**Re: FortisBC Energy Inc. (FEI)**

**Application for a Certificate of Public Convenience and Necessity (CPCN) for the  
Okanagan Capacity Upgrade (OCU) Project (Application) ~ Project No. 1599152**  
**Response to the British Columbia Utilities Commission (BCUC) Information  
Request (IR) No. 1 on Supplementary Filing**

FortisBC Energy Inc. (FEI or the Company) Application for a CPCN for the Okanagan Capacity Upgrade (OCU) Project (Application)	Submission Date: July 14, 2023
Response to the British Columbia Utilities Commission (BCUC) Information Request (IR) No. 1 on Supplementary Filing	Page 1

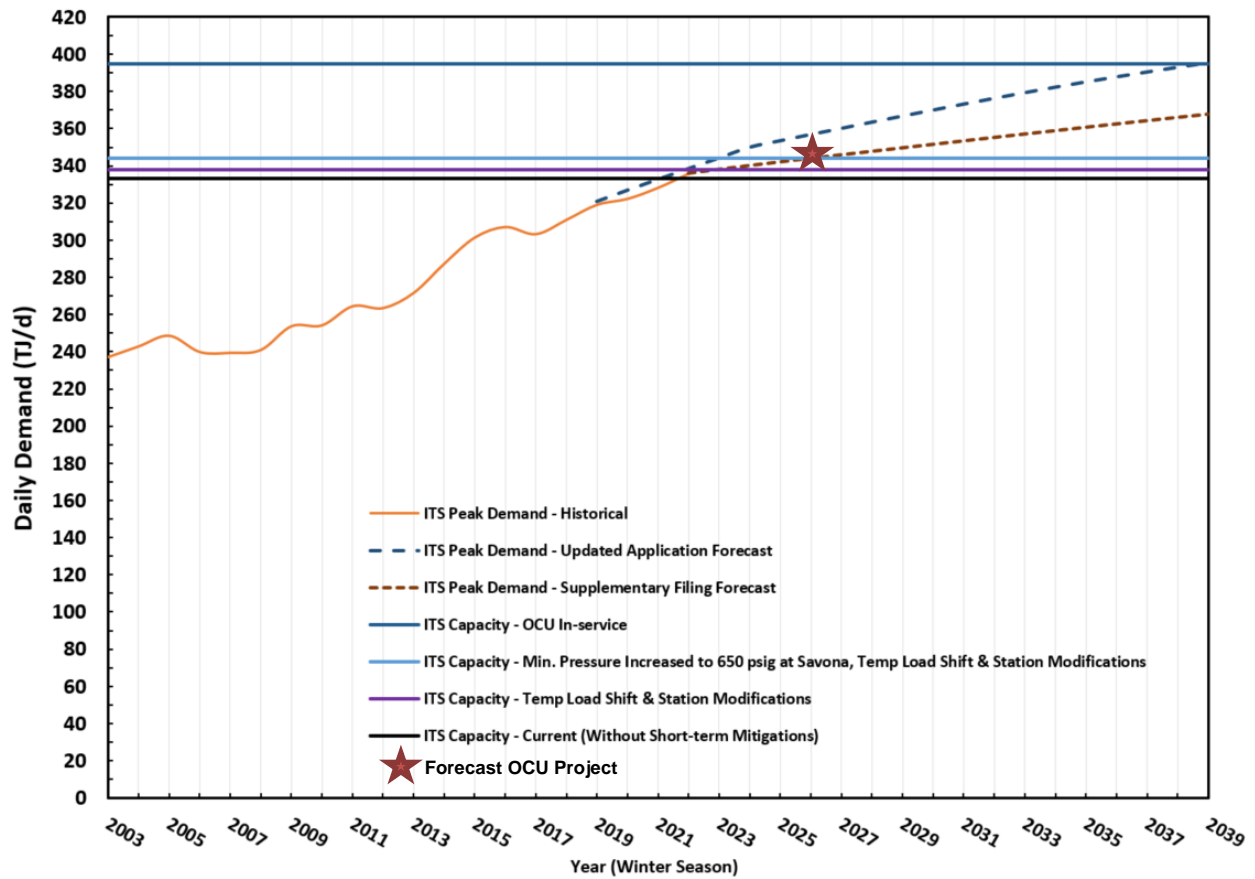
1.9 Please provide an annotated version of Figure 2-1 that shows current ITS capacity, ITS capacity with temporary load shift and station modifications, ITS capacity with temporary load shift, station modifications, and increased Savona tap pressure, ITS project completion, ITS capacity with OCU in service, and ITS capacity with OCU in service and compressor upgrades (if any).

Please see the updated Figure 2-1 below and the accompanying table with the addition of the ITS capacity with temporary load shift, station modifications, and increased Savona tap pressure. FEI interprets the reference in the IR to “ITS project completion” as the year the OCU Project is expected to be in-service. As discussed in Section 3 of the Supplementary Filing, the OCU Project is expected to be in-service before Winter 2026/2027, which is marked on the figure below as an orange star. With regard to compressor upgrades, as discussed in the response to BCUC Supplementary IR1 1.10, compressor upgrades no longer have an impact on the capacity with the OCU Project in-service due to the revised pressure assumption at the Yahk Tap.

**Figure 1: Updated Figure 2 – RS 3 Customer Forecast**

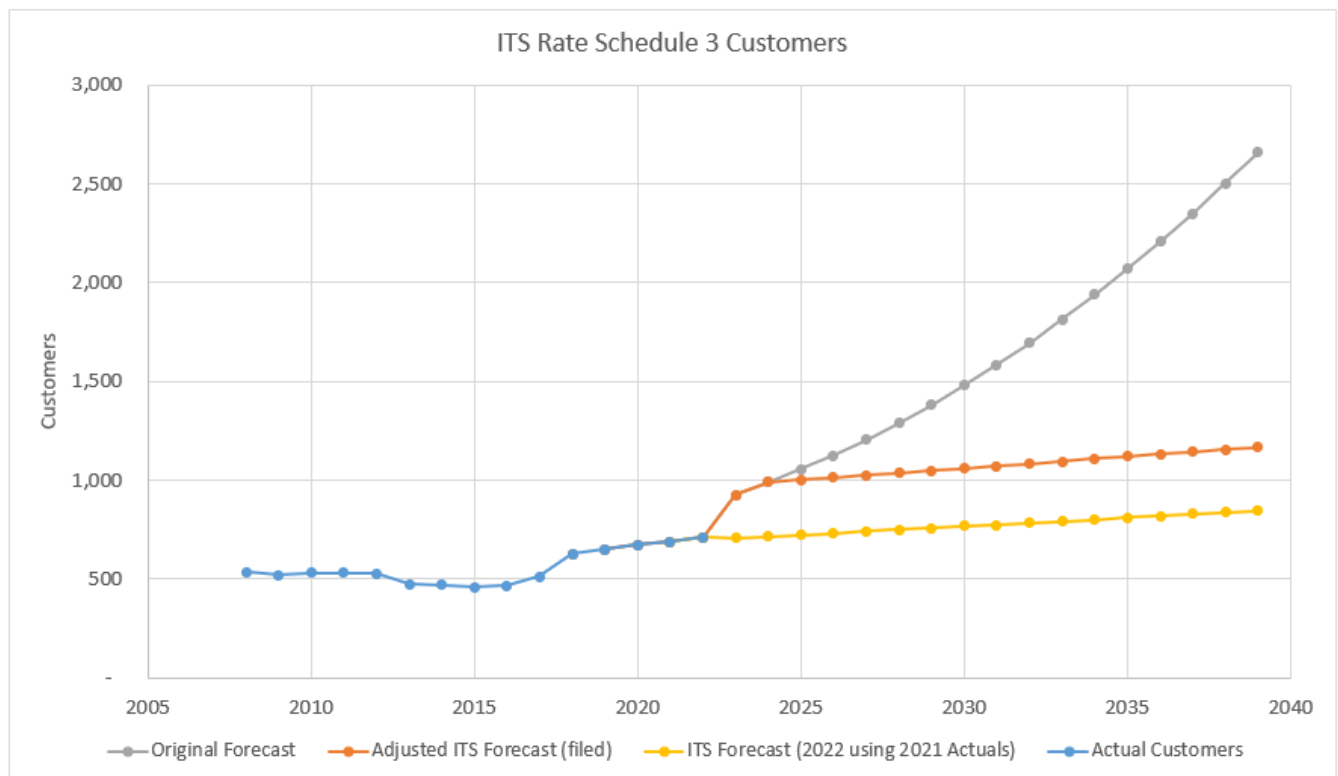
2.2 Please update Figure 2 of the RS 3 customer forecast in the preamble for the new ITS peak demand forecast. Additionally, please discuss in detail any adjustments made.

The following Figure 1 is an update to Figure 2 in the preamble. The yellow line represents the RS 3 customer additions forecast for the ITS and is based on 2021 actual data. The slope of the new forecast is very similar to the Adjusted ITS Forecast (orange) and confirms that the original decision to treat the 2018 additions as an outlier and adjust the forecast was appropriate.

**Figure 1: Overlay of Figure 3 with Figure 2-1**

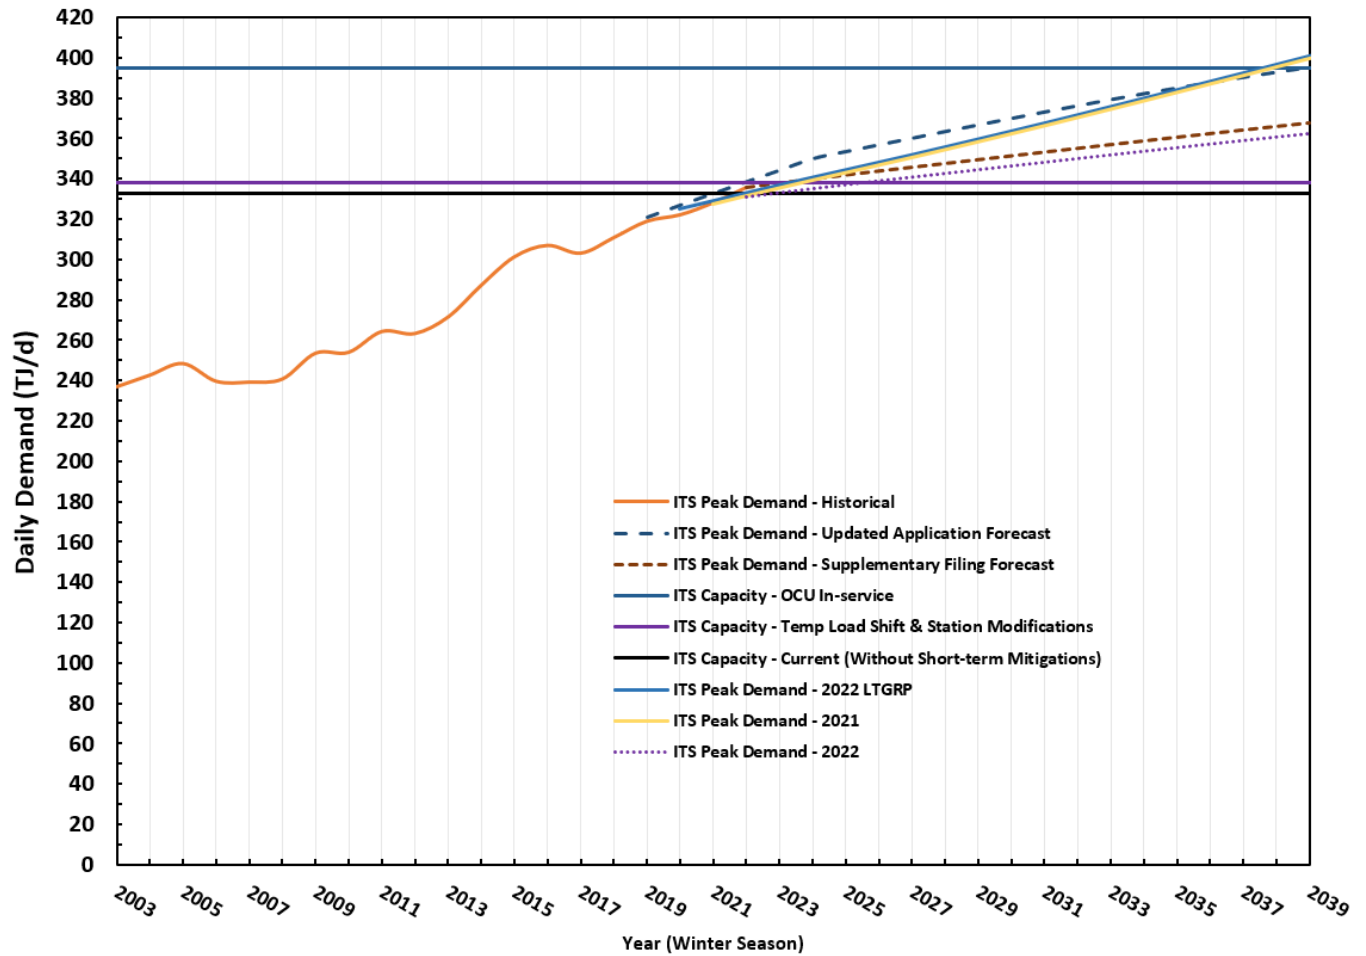
2.6 Please overlay Figure 3 of the ITS Traditional Peak Demand comparison shown in the preamble with Figure 2-1 of the Supplementary Filing Peak Demand Forecast.

The following Figure 1 overlays Figure 3 in the preamble to this IR with Figure 2-1 of the Supplementary Filing.

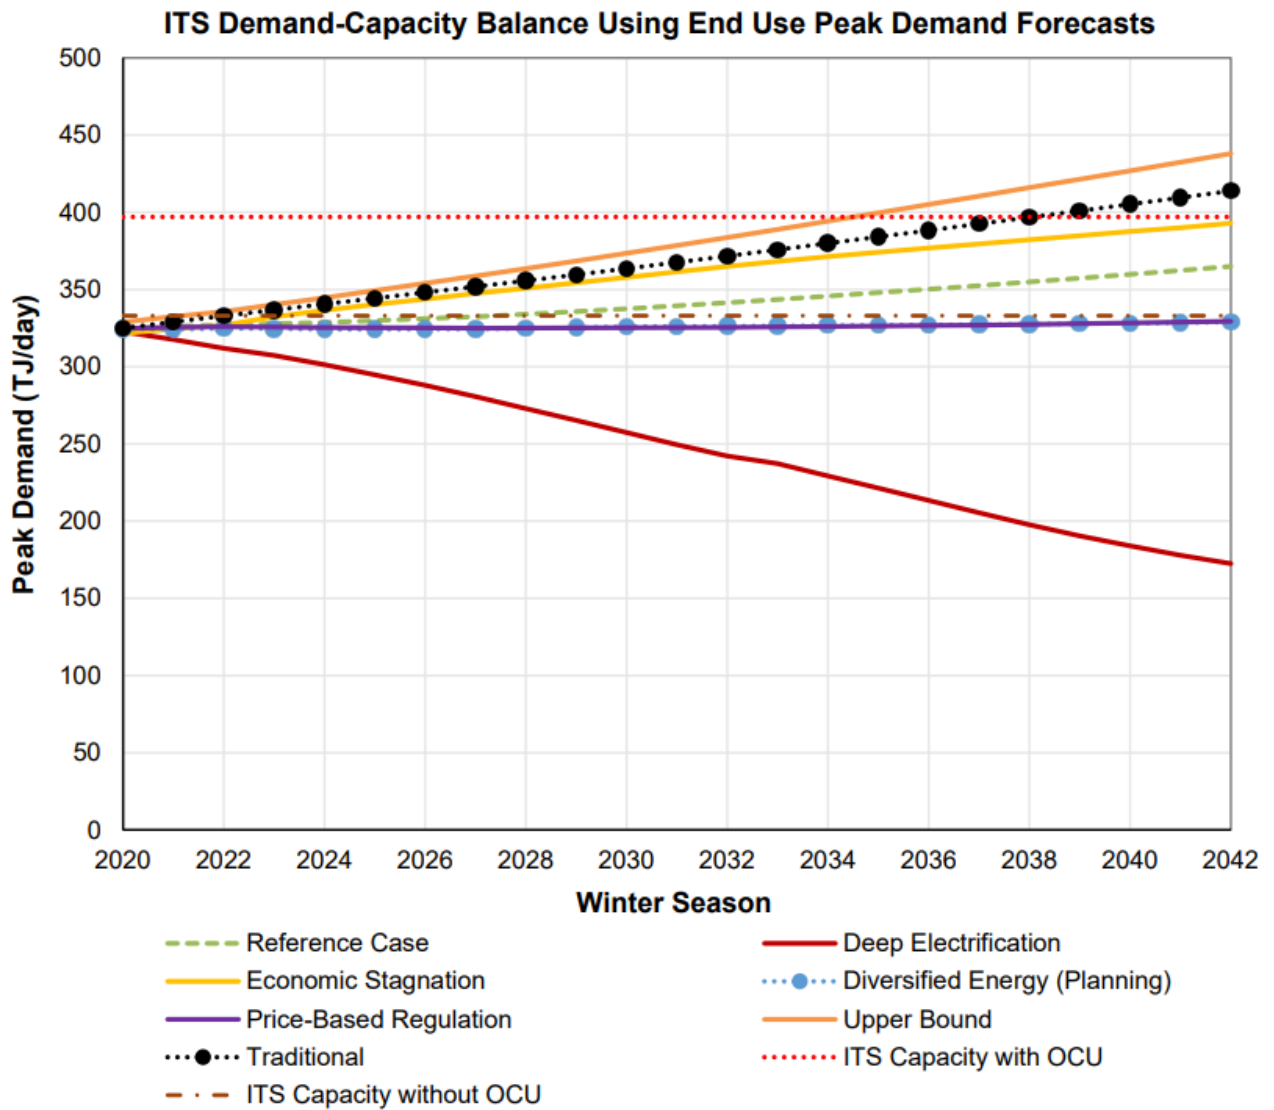
8.1 Please provide a discussion of the need for the OCU project under the end-use peak demand forecasts outlined in the 2022 LTGRP, for each scenario shown in Figure 7-15 in the preamble.

6 The Traditional Peak Demand Method is not a scenario method like the end-use forecasts shown  
7 in Figure 7-15. Further, it cannot be directly related to the scenarios used for the exploratory end-  
8 use peak demand forecast.

9 As shown in the figure below, if FEI were relying on the exploratory end-use method for peak  
10 demand, the version of Figure 7-15 showing Existing Capacity without OCU, as well as Existing  
11 Capacity with OCU<sup>9</sup>, shows that the Traditional Peak Demand forecast, along with the exploratory  
12 Upper Bound, Economic Stagnation and Reference Case scenario peak demand forecasts, will  
13 not be met with the capacity available in the ITS without the OCU Project.
